SERVICE BULLETIN

Classification: BT10-004	Reference: NTB10-014	Date: January 26, 2010
-----------------------------	-------------------------	---------------------------

2009 370Z COUPE; REAR HATCH WILL NOT OPEN ON FIRST PUSH OF RELEASE BUTTON

APPLIED VEHICLE: 2009 370Z Coupe (Z34)
APPLIED DATE: Vehicles built before October 6, 2009

Figure 2

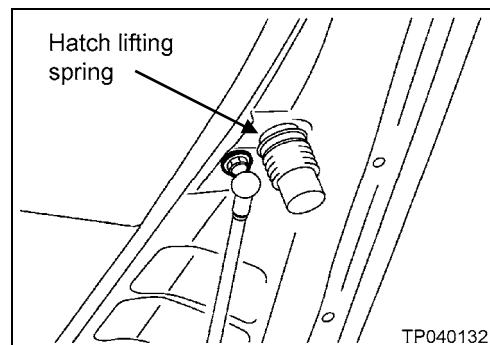
3. Replace the rear hatch lifting springs.
 - Use the new springs listed in the Parts Information section.
 - Remove by turning the springs $\frac{1}{2}$ turn in either direction.
 - Install in reverse order.
